Additional Evidence Presented in Connection with Steven Harper's Continuance Remarks

Ryan Field Redevelopment at Northwestern University **Review of WJHW Environmental Assessment Documentation**

To Steven Harper, Esq.
Date September 27, 2023
Copies
Reference number 296698-00
From Ryan Biziorek
File reference M03
Subject Ryan Field Redevelopment at Northwestern University – Review of WJHW Rebuttal to Arup

Figure 1: Long term noise measurement sound levels logged at 640 Gregory Avenue (Reprinted from M01 with additional day notations)

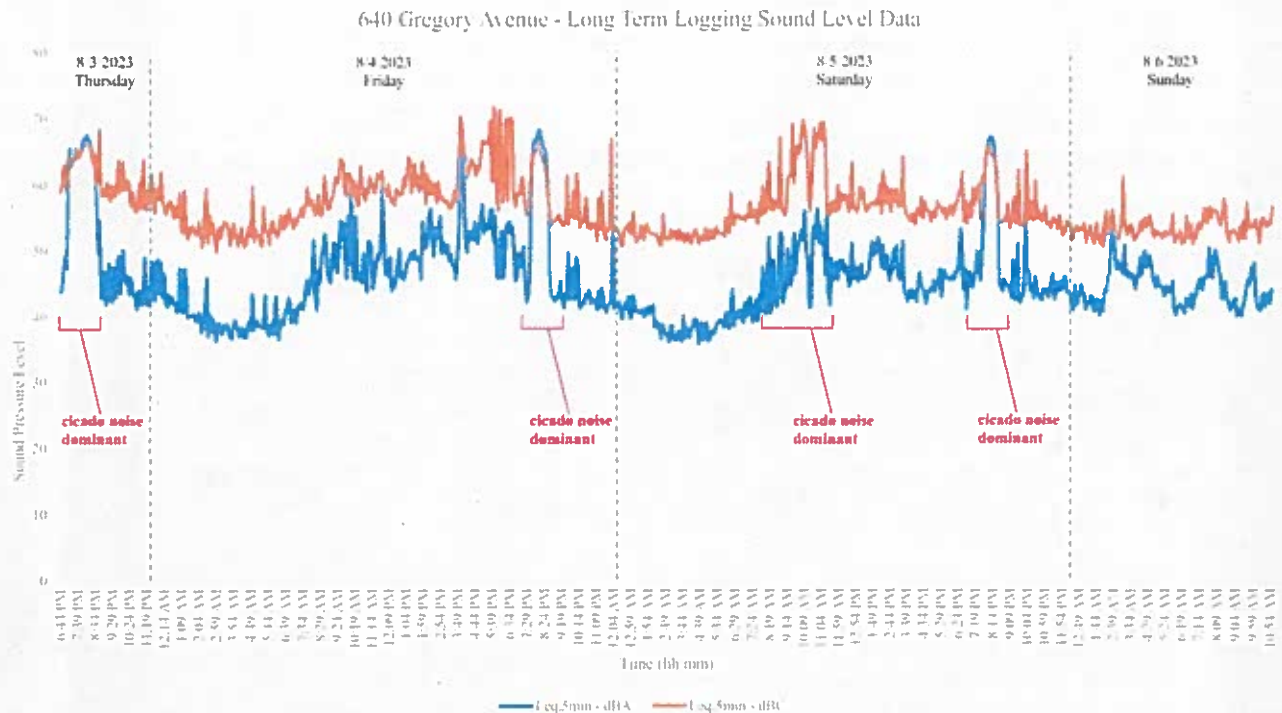
Assuming that WJHW was referencing the Henderson non-gameday measurements, Arup did conduct a long term 64 hour measurement at two locations in Wilmette and presented the results in Table 2 and Figure 4 of M01. Review of Figure 4 (reprinted below as Figure 1) illustrates that the logged levels on Thursday evening are comparable to those on Friday and Saturday evening during the proposed concert event hours. Based on this data, the ambient sound levels on Thursday evening are not necessarily quieter than non-gameday weekend evenings.

Figure 4: Concert Environmental Assessment Results (dBA)

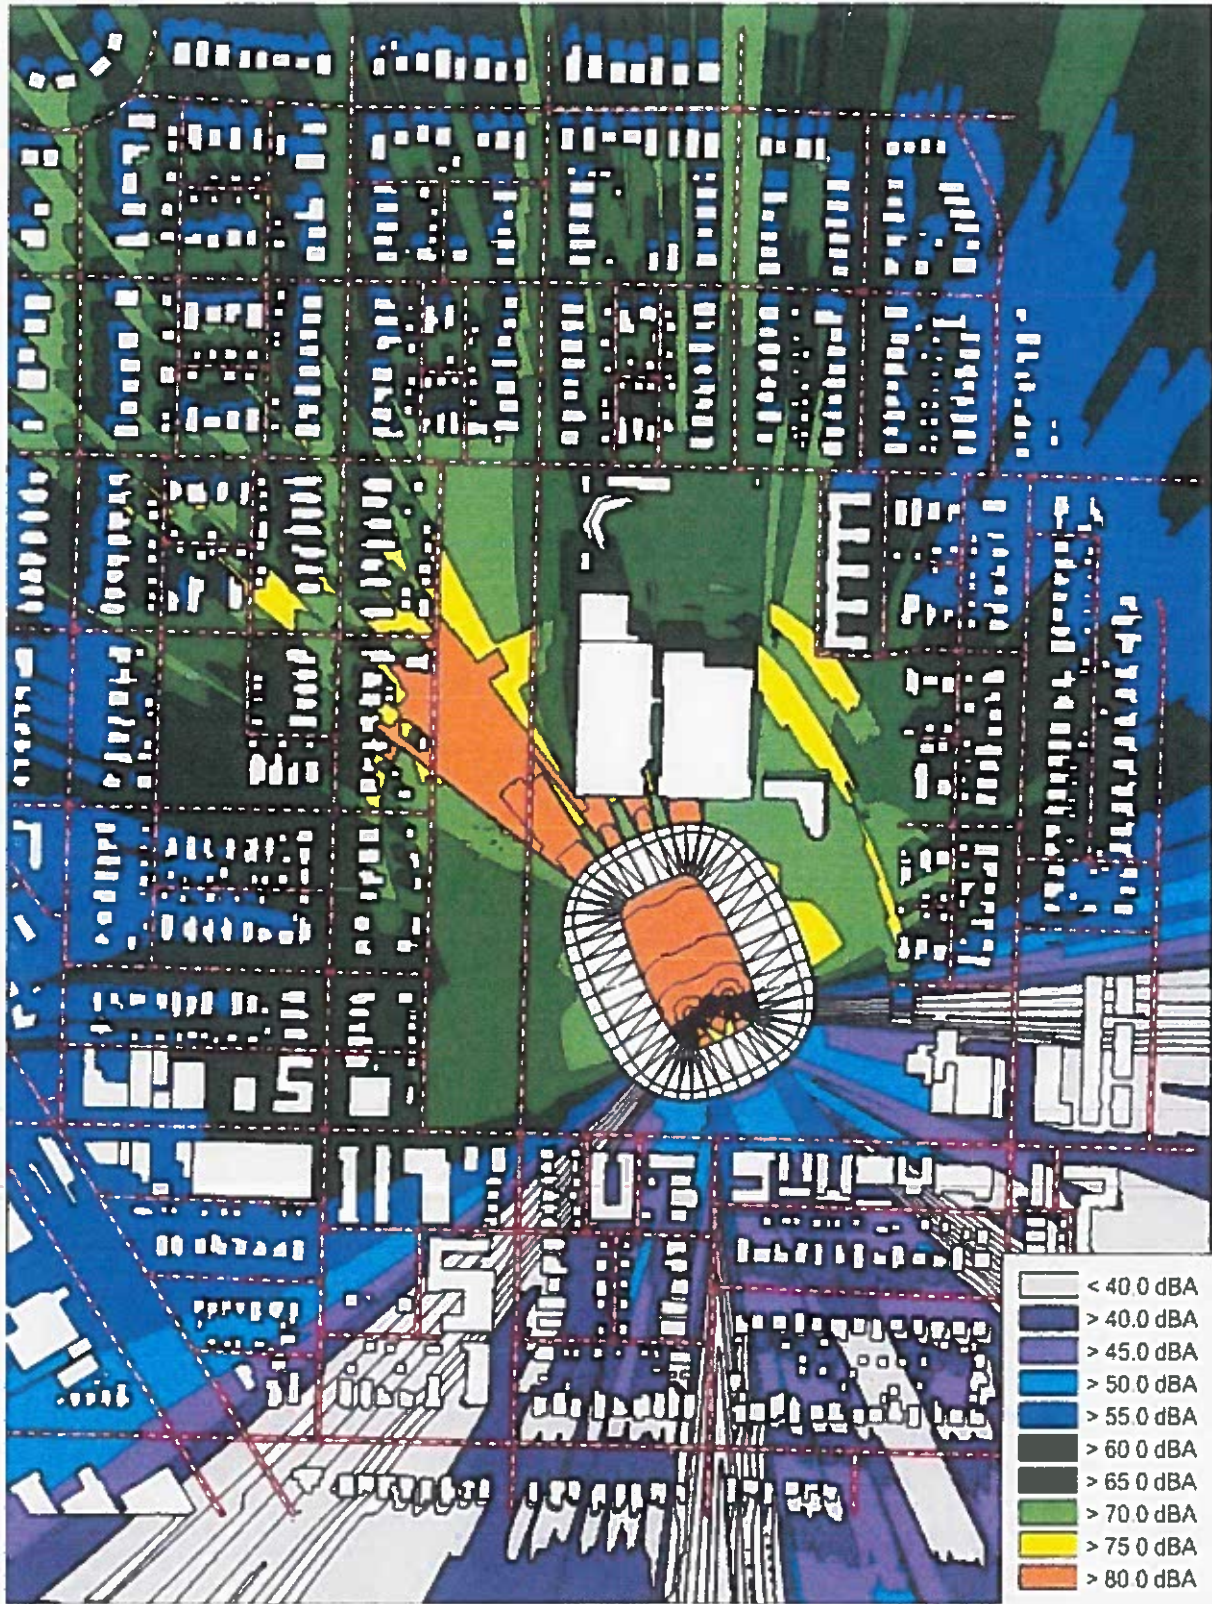
4. Henderson's predicted concert noise levels taken from Figures 4 and 5 of WJHW letter 4.
5. Noise levels assessed for areas and facades with Southern and Eastern exposure towards Ryan Field and not shielded by the immediately adjacent home (if applicable).
